National Committee on Uniform Traffic Control Devices

Recommended Changes to Proposed Text for 11th Edition of the MUTCD

Docket Number: FHWA-2020-0001

NPA MUTCD Section Number: Sections 9D.01 – 9D.13

Figure 9D-1. Guide Signs and Plaques for Bicycle Facilities (Sheet 1 of 2)

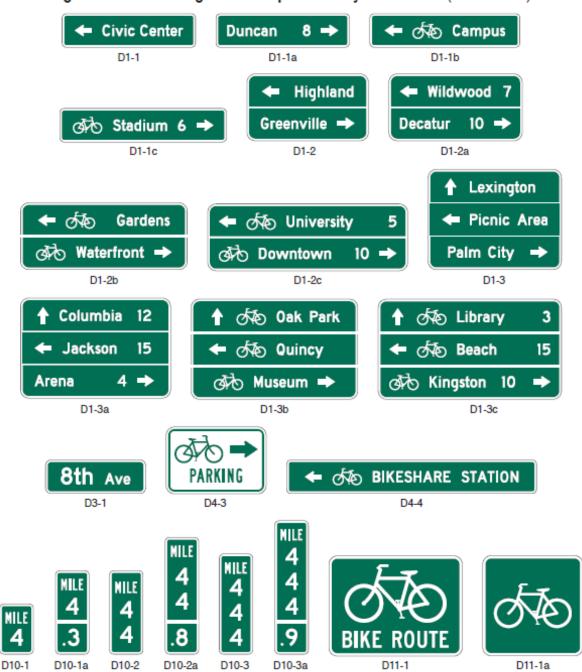
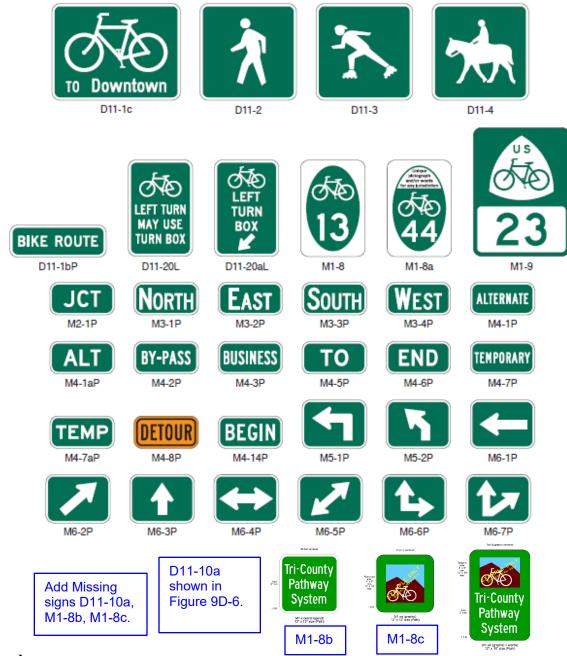
NCUTCD generally agrees with Figure 9D-1 as presented in the NPA, but recommends adding signs D11-10a, M1-8b, and M1-8c to Sheet 2 of 2 in accordance with NCUTCD recommendation 14A-BIK-02.

Figure 9D-3. Examples of Bicycle Route Guide Signing

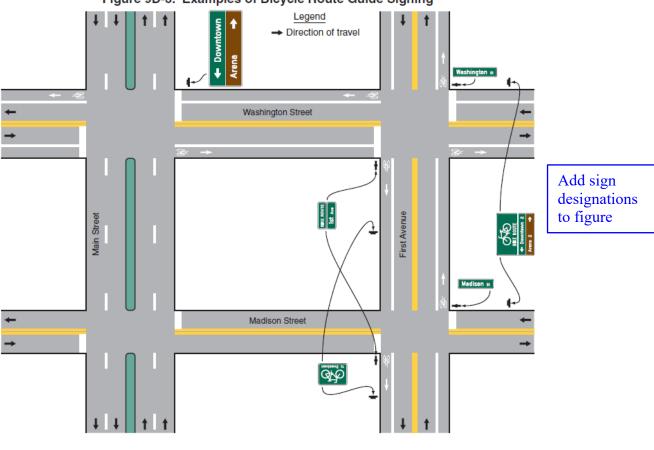
NCUTCD generally agrees with Figure 9D-3 in the NPA, but recommends adding sign designations.

Figure 9D-X. Illustration of Bicycle Route Directional Assemblies (for One Direction of Travel Only)

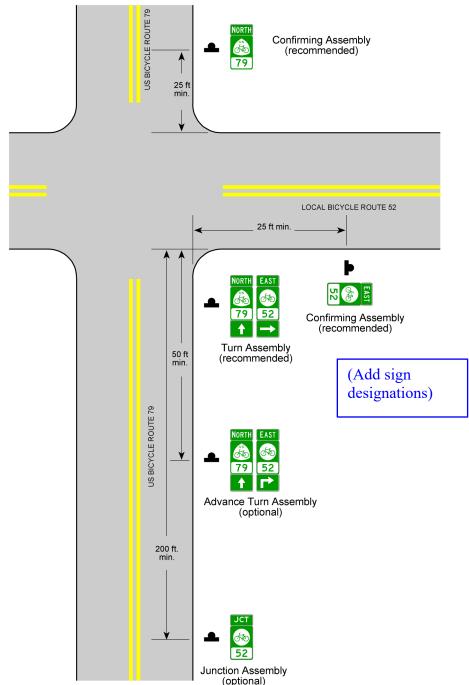
NCUTCD recommends adding a new Figure 9D-xx addressing bike route directional signing in accordance with NCUTCD recommendation 15B-BIK-01.
